RICOH Modification Bulletin

Model: Fax Unit type 200 (A639) Date			e: 31-Jul-97	No: 1			
Modified Article: Parts catalog correction			Prepared by: M.Horiike				
From: QAC 2nd Field Information Dept.							
Reason for	□ Parts catalog correction	☐ Vend	or ch	nange			
Modification: ☐ To facilitate assembly ☐ To improve reliability ())		
	☐ Part standardization	☐ Other

Model: Fax Unit Type 200/250 Date			e: 15-Apr-98	No: 2A	
Modified Article: Part catalog correction			Prepared by: K.Ugaeri		
From: QAC Field Information Dept.					
Reason for	□ Parts catalog correction	☐ Vendo	or cha	ange 🔲 To r	neet standards
Modification:	☐ To facilitate assembly	$^{\prime}$ \square To improve reliability $^{(}$ $)$			
	☐ Part standardization	Other

Model: Fax Unit Type 200 (A639) Date			e: 31-Aug-98	No: 3
Modified Article: HDD Option		Prepared by: K.Ugaeri		
From: QAC Field Inf	ormation Dept.			
Reason for	Parts catalog correction		nange 🔲 To r	neet standards
Modification:	☐ To facilitate assembly	☐ To improv	/e reliability ()
	☐ Part standardization	☐ Other

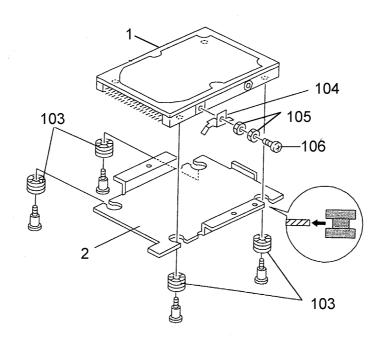
The current HDD unit has been discontinued by the supplier. A new HDD unit has been set up.

Old part	New part	Description	Int	Q'ty	Index	Page
number	number					
G6905723	H5157119	HDD – MK0803MAT		1→1	1	23
A1945817	A1945820	Bracket – HDD		1→1	2	23
04513006B		Tapping Screw – M3x6	0/0	6→2	101	23
	A1935843	Stepped Screw	≻as a set	0→4	102	23
	AA161125	Rubber Cushion		0→4	103	23
	A1935842	Grounding Plate – HDD		0→1	104	23
	07120030W	Nut – M3		0→1	105	23
	03130050B	Philips Pan Head Screw – M3x5		0→1	106	23

When an old HDD will be replaced with a new one, replace all parts in the above table.
